# Community Consultation

# Response Rate

# Road Safety Proposals

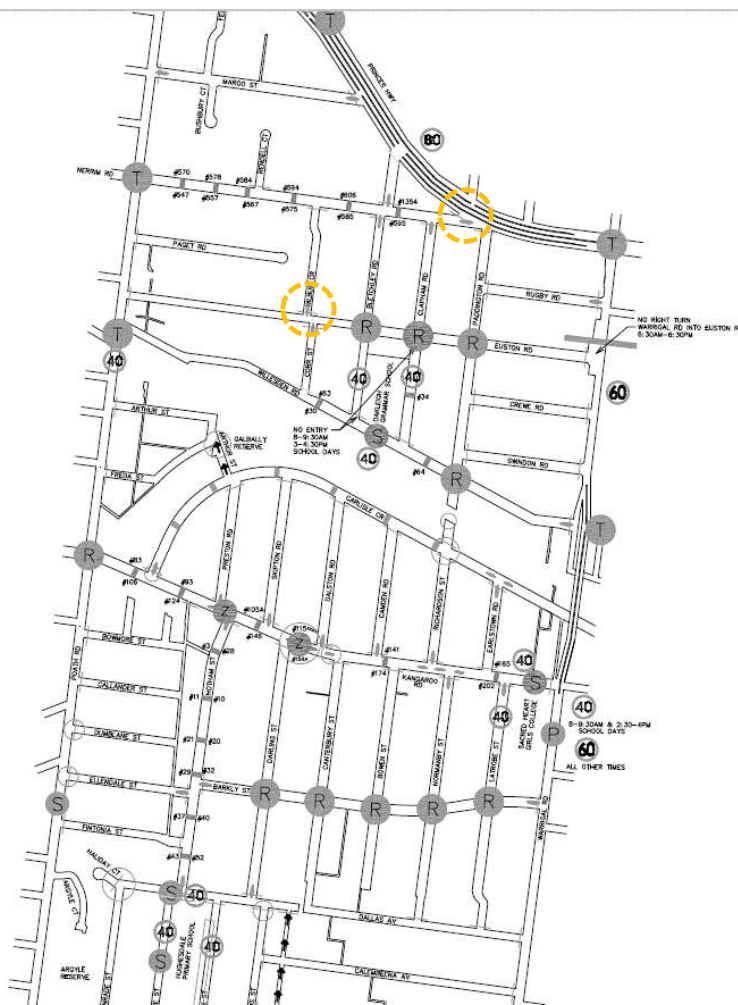
- Concern the roundabout will increase crashes.
- Apply left out only should apply at specific times.

- Very good levels of agree/neutral responses for both proposals (87-90%).
- Comment from adjacent property (negative) is that a roundabout will increase crashes. Roundabouts result in reduced crashes and reduced severity of crashes.
- Some requests for turn bans to also be placed in Crewe Rd & Swindon Rd. Acknowledge that some vehicle may divert to these street.
- **Recommendation:** **Proceed** with both proposals. Monitor volumes in Crewe Rd & Swindon Rd

# Operational Issues

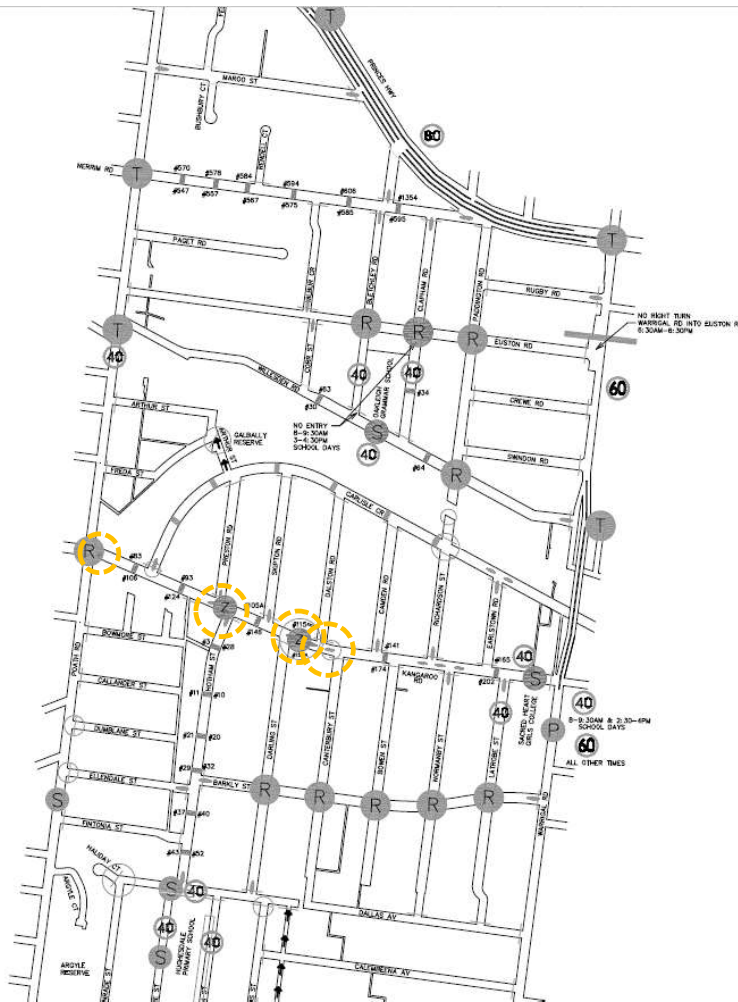
- Concern that splitter island wont allow for truck movements (i.e. waste collection).

- Very good levels of agree/neutral responses for both proposals (88-89%).
- The only negative comment related to the ability of the proposed splitter island on Wilbur Crescent to accommodate waste vehicles.
- The detailed design of the splitter island will consider waste vehicles, with potential for the island to be semi-mountable to accommodate truck movements.
- **Recommendation:** Proceed with both proposals.

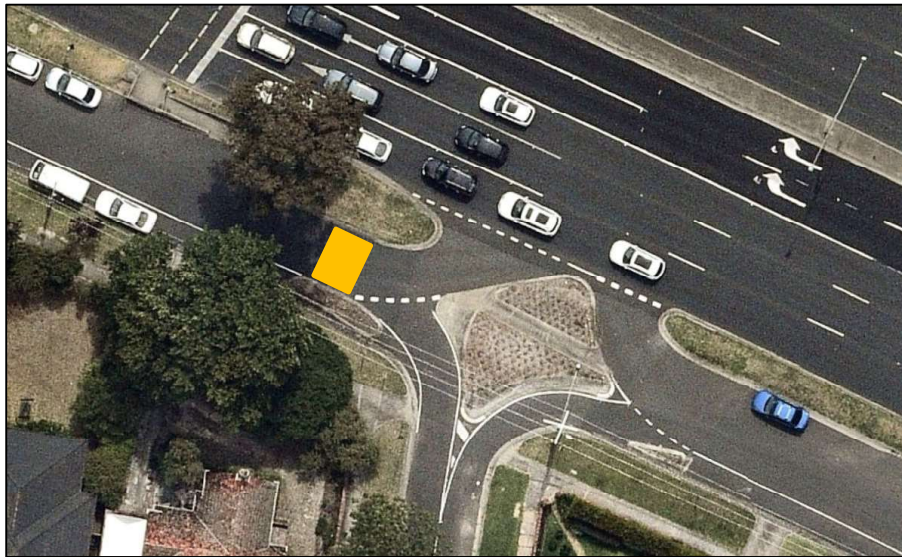
- **Hughes Place:**
  - Request for speed management near playground.
  - **Recommendation:** Install surface treatment and speed cushions to highlight pedestrian area.
